February 22, 2017

Engineering Change Notification

This notice is to inform you of a change to the following Serial LCD product(s):

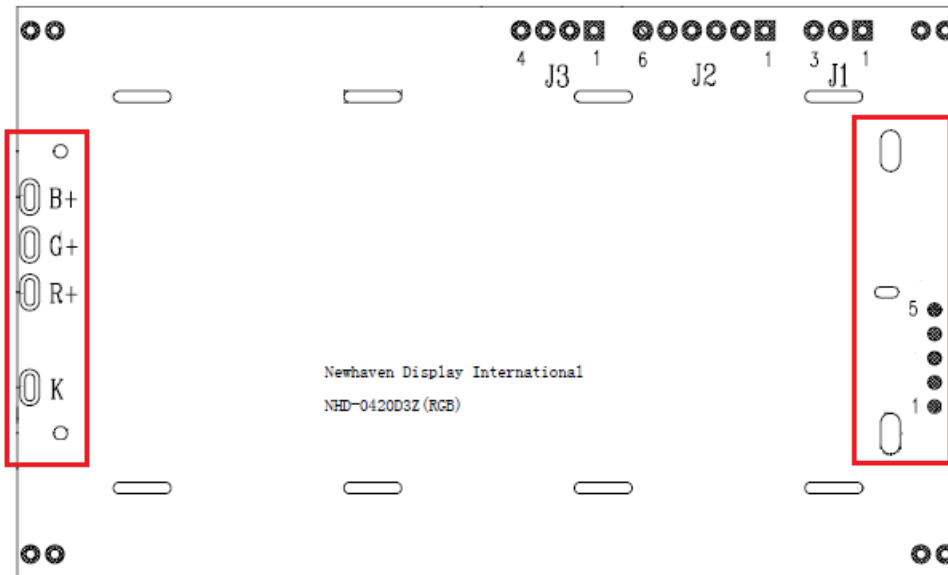
The backlight module on these displays has been redesigned to include new latches and alignment tabs for improved attachment of the backlight onto the display PCB.

This design improvement should not have any effect on the form, fit or functionality of the display in your application. We understand each project is unique and therefore recommend you review the updated datasheet and evaluate new samples for validation.
